Work Order ID 126595

Item ID: D206-642-341 Accept ***N900040100*** Setup Start ***NS1***
 Revision ID: Stop ***NS2***
 Item Name: Replacement Skidtube, Low & High Gear with Standard Wearplates Fits LH or RH
 Start Date: 11/14/2014 Start Qty: 1.00 ***1*** Cust Item ID:
 Required Date: 11/14/2014 Req'd Qty: 1.00 ***1*** Customer:
 Reference:

DRAWING NO. D2650	TITLE 206/407 SKIDTUBE ASSEMBLIES	REV. F	DART AEROSPACE LTD ENGINEERING ORDER		D.E.O. NO. D2650-F-1	SHEET NO. SHEET 1 OF 1	SCALE NTS
DRAWN <i>[Signature]</i>	CHECKED A.P.	MFG. APPR. <i>[Signature]</i>	APPROVED <i>[Signature]</i>		DE APPR. <i>[Signature]</i>		
DATE 12.10.12	DATE 12.10.22	DATE 12.10.22	DATE 12.10.22		DATE 12.10.22

17	18	19	23	D2649	CROSS BOLT SPACER
----	----	----	----	-------	-------------------

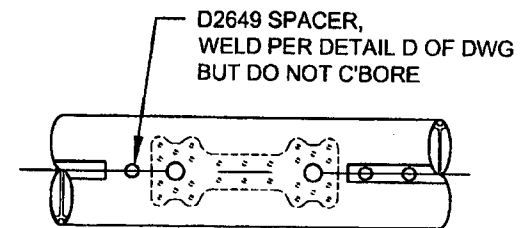
CHANGE C'BORED WELDED CROSSBOLT SPACERS TO SWAGED SPACERS

WAS:

AMENDMENT TO DETAIL B
NOT TO SCALE

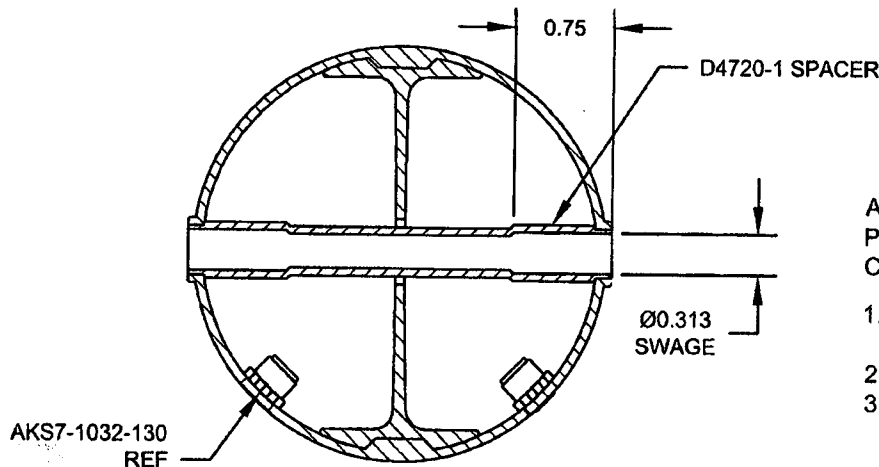
ADD DETAIL G BELOW, WHICH IS THE SAME SECTION VIEW AS DETAIL D OF DWG.
C'BORED HOLES ARE **NOW SWAGED** PER DETAIL G BELOW. FOR THE Ø0.375 HOLE THAT IS NOT C'BORED, WELD PER DETAIL D OF DWG (SEE AMENDED DETAIL B FOR REFERENCE).
